## Process Sheet

Customer : CU-DAR001 Dart Helicopters Services Drawing Name : MOUNTING BRACKET  
 Job Number : 38531  
 Estimate Number : 10250  
 P.O. Number :  
 This Issue : 10/04/2008 S.O. No. :  
 Prsht Rev. : NC  
 First Issue : / / Type : MACHINED PARTS  
 Previous Run : 35362  
 Part Number : D2053  
 Drawing Number : D2053 ~~00000000~~ R 08-04-11  
 Project Number : N/A  
 Drawing Revision : U/R  
 Material :  
 Due Date : 05/05/2008 Qty: 30 Um: Each  
 Written By :  
 Checked & Approved By : JD 08-4-10  
 Comment : Est D 02.03.18 Added Rev.B NG  
 (Issue this IPP with part number D2052)  
 Est Rev E now water jet 07-10-25 DD

**D2053 BRACKET**

**From:** David Shepherd [dshepherd@dartaero.com]  
**Sent:** April 27, 2008 1:17 AM  
**To:** 'Peter Hum'  
**Cc:** 'Mike Petsche'  
**Subject:** RE: D206-558 -> D2053 Bracket

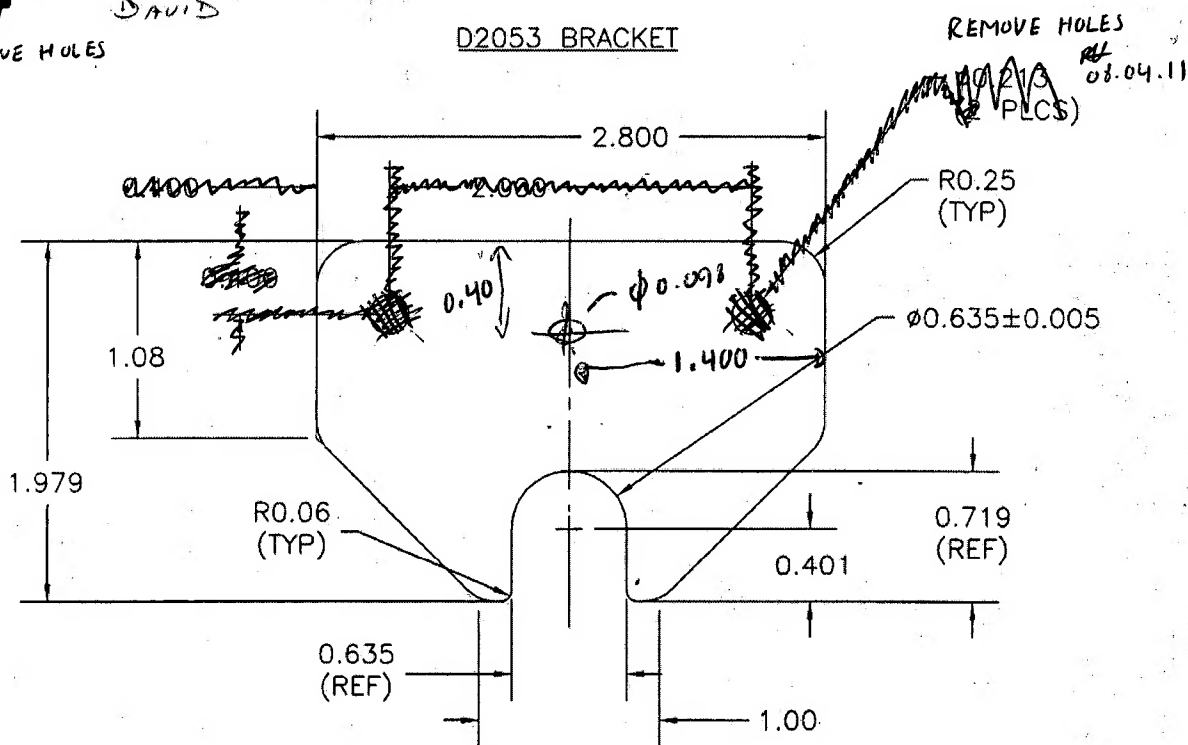
W/O:		WORK ORDER CHANGES					
DATE	STEP	PROCEDURE CHANGE	By	Date	Qty	Approval Chief Eng / Prod Mgr	Approval QC Inspector
08.04.22	4	<del>1.211</del> • Remove QTY (2) $\phi$ 0.213 holes • Drill $\phi$ 0.098 @ 1.40 and 0.40 AS per Drawing	FF	08/04/30	46	<del>KE</del> QSI 042 08.04.22

Ø 0.213 MAY COME  
OUT? check with  
DAVID  
REMOVE HOLES

Per our phone conversation, I have clarified the location of the 0.098" hole (see attached) to be added. As previously discussed, the 0.213" holes are removed and will be drilled by the customer.

DESIGN	DRAWN BY	<b>DART AEROSPACE LTD</b> HAWKESBURY, ONTARIO, CANADA	
CHECKED	APPROVED	DRAWING NO. D2053	REV. B SHEET 1 OF 1
DATE 02.03.12		TITLE BRACKET	SCALE 1:1
A	92.01.12	NEW ISSUE	
B	02.03.12	ø0.635 WAS ø0.437; 0.635 WAS 0.325

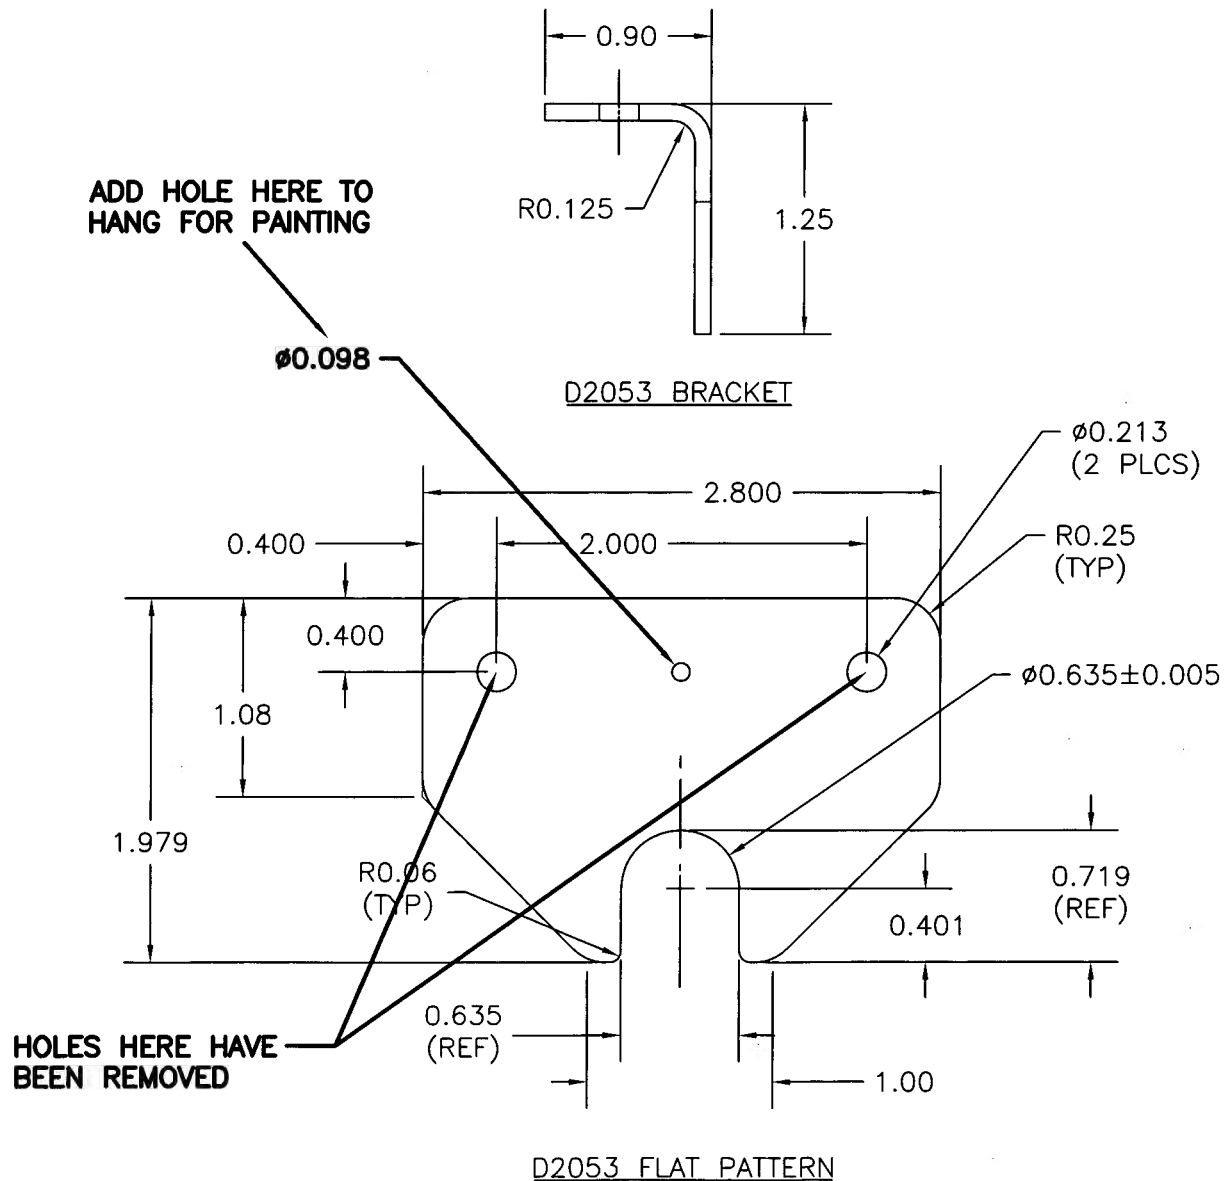
It seems like the last production of these parts had a 0.098" hole drilled on the centerline to allow the finishing to hang the piece for powder coating. However, the last work order has been misplaced.

Therefore, is it acceptable to drill the 0.098" hole as shown in the attached sketch? Chris or myself does not have delegation to sign off this change.

As discussed, the changes are acceptable for the batch that is being made.
